RS-18-005

Clinton Power Station, Unit 1
Facility Operating License No. NPF-62
NRC Docket No. 50-461

Subject: License Amendment Request to Incorporate Revised Alternative Source Term
Dose Calculation

ENCLOSURE 1 – PROPOSED TECHNICAL SPECIFICATIONS CHANGE (MARK-UP)

TABLE 15.6.5-6
LOSS-OF-COOLANT ACCIDENT (DESIGN BASIS ANALYSIS)
RADIOLOGICAL EFFECTS*

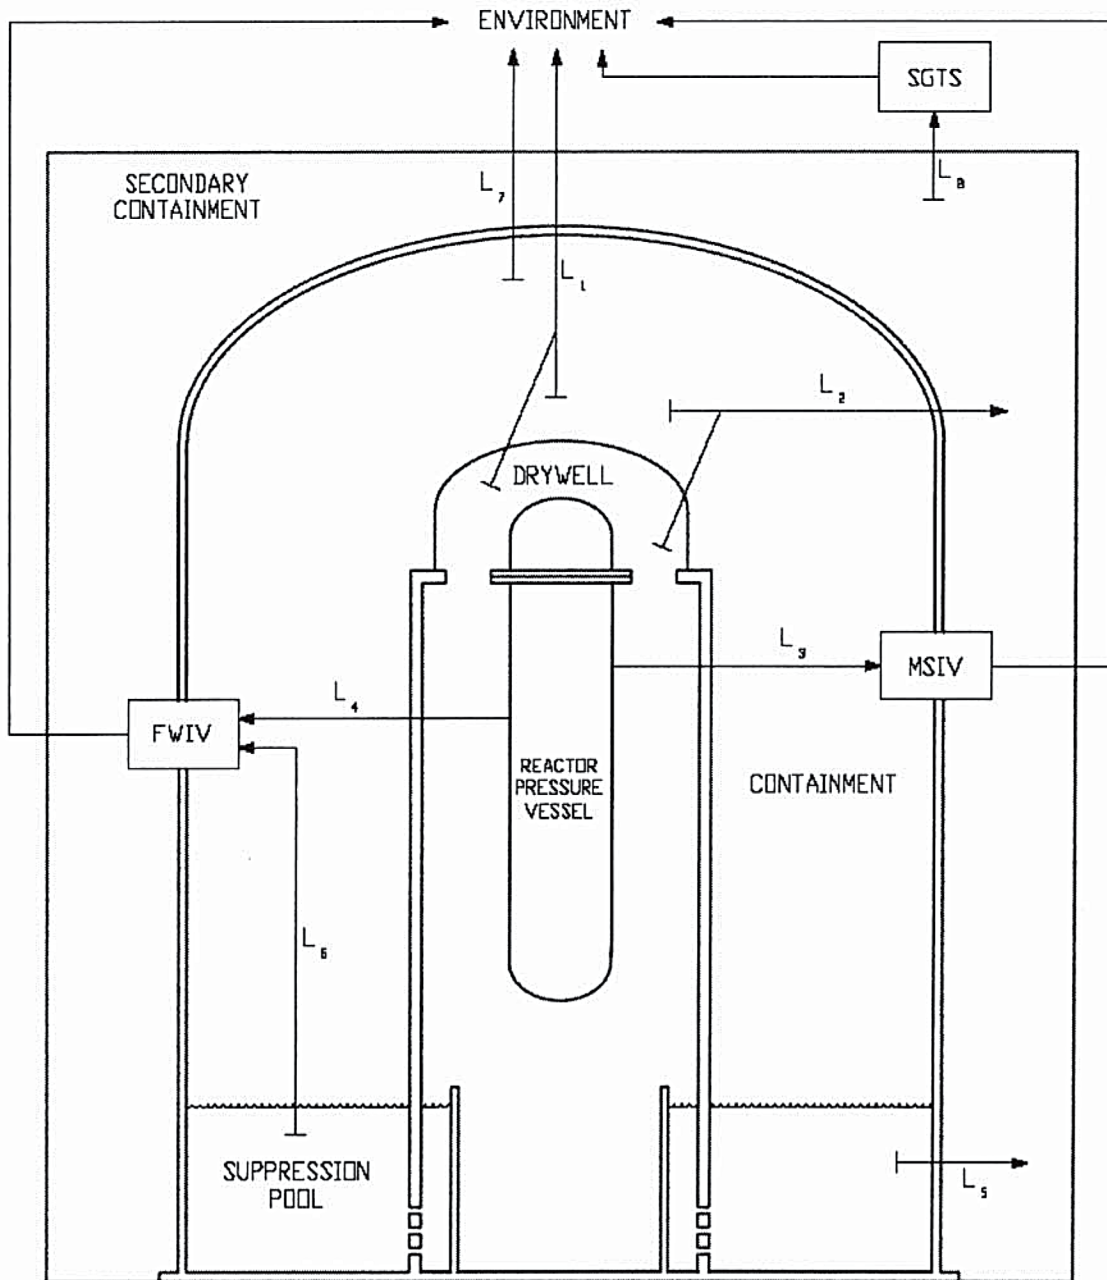
However, the increase in post-accident Control Room dose, which is documented in USAR Subsection 15.6.5.5.2, "Control Room," while within the 10 CFR 50.67 limit, was more than minimal, and as such requires prior NRC approval. Specifically, the postulated post-LOCA Control Room dose will increase from the current value of 4.84 roentgen equivalent man (REM)

to 4.89 REM Total Effective Dose Equivalent (TEDE), relative to the RG 1.183, 10 CFR 50.67, and 10 CFR 50, Appendix A, "General Design Criteria for Nuclear Power Plants," Criterion (GDC) 19, "Control Room," limit of 5 REM TEDE. The sensitivity study results for a 12 to 24-month fuel cycle demonstrated that the dose consequences based on an annual fuel cycle core inventory are bounding.

<u>TEDE</u>
EXCLUSION AREA BOUNDARY (975 Meters)	17.31 ← 16.18
LOW POPULATION ZONE (4018 Meters)	7.42 ← 6.81
